Subject: Tesla Power Plant (01-AFC-21C)  
Data Responses

# **Tesla Power Project (01-AFC-21C)**

## **Data Responses**

**WORST CASE STARTUP CURVES FOR NO<sub>x</sub> (COLD START) AND CO  
(WARM START)**

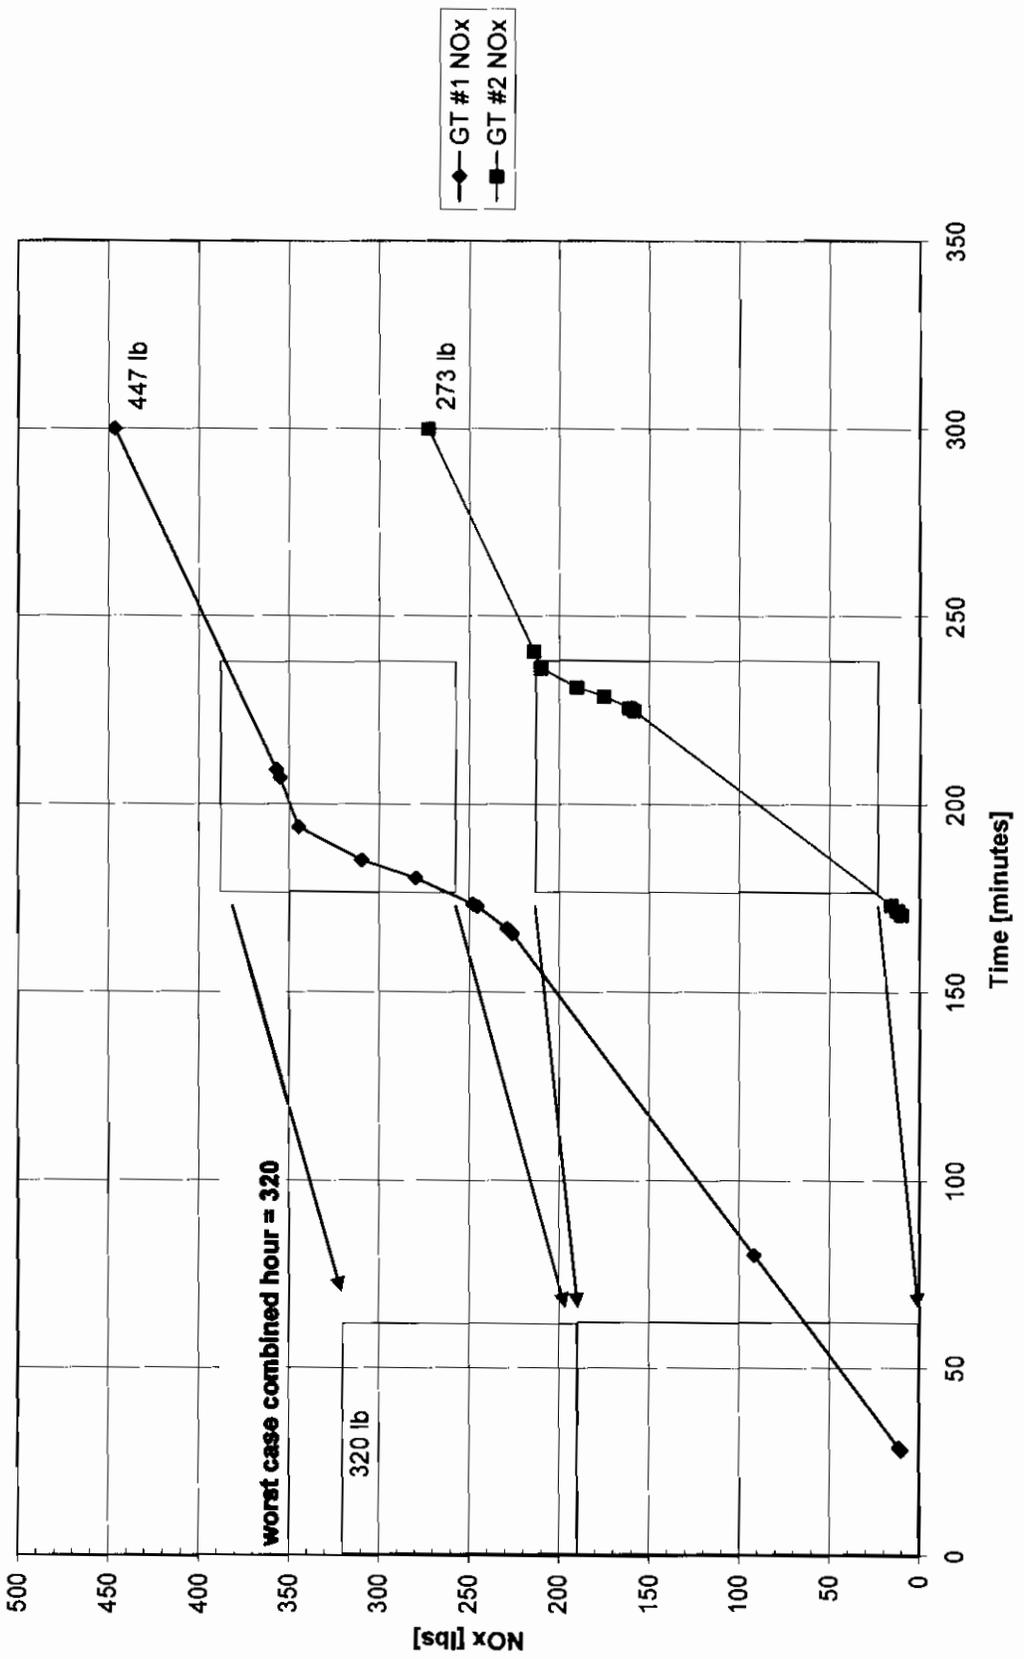
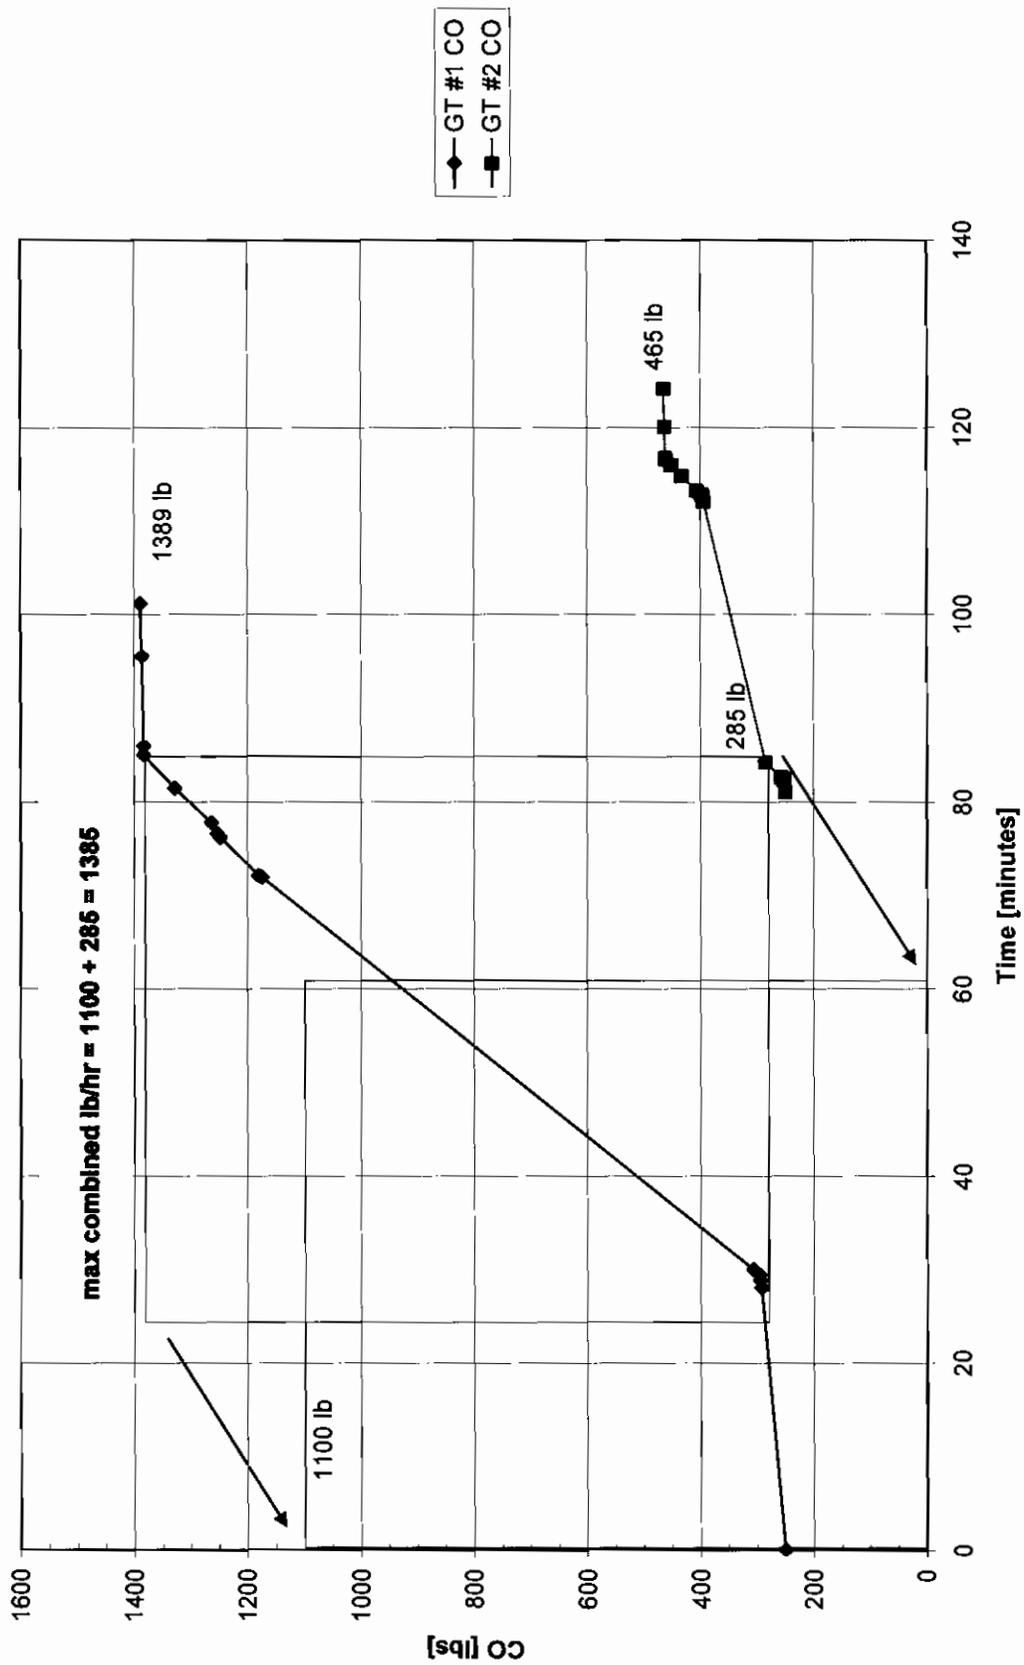
8. Please provide the basis for the NO<sub>x</sub> and CO combined emission and calculations supporting the proposed emission limits in AQ-27, and revise the proposed limits in AQ-27 and AQ-13, as needed.

9. Please verify that the emission limits in AQ-27 and AQ-28 in the petition are correct given the expected commissioning emissions in AQ-13 and operating constraints of AQ-26.

The startup curves for NO<sub>x</sub> and CO are attached for reference. A simultaneous start of the two 2 x 1 pairs would result in combined NO<sub>x</sub> emissions of 640 lb/hr (2 pairs x 320 lb/hr/pair) during a cold start and combined CO emissions of 2770 lb/hr (2 pairs x 1385 lb/hr/pair) during a warm start.

The emission limits as proposed are correct. Please refer to the attached cold start and warm start profiles attached. The NO<sub>x</sub> profile demonstrates that each 2 x 1 unit would result in a maximum one-hour NO<sub>x</sub> emission rate of 320 lb/hr. A simultaneous start of two pairs of 2 x 1 units would result in a total NO<sub>x</sub> emission rate of 640 lb/hr (2 x 320 lb/hr/pair). Similarly the CO profile demonstrates that each 2 x 1 unit would result in a maximum one-hour CO emission of 1385 lb/hr. A simultaneous start of two pairs of 2 x 1 units would result in total CO emission rate of 2770 lb/hr (2 x 1385 lb/hr/pair). Since the requested startup sequence will require a limited period when all four units will emit in excess of the normal operation emission limits, Midway Power has requested and the BAAQMD has agreed to delete Condition AQ-26.
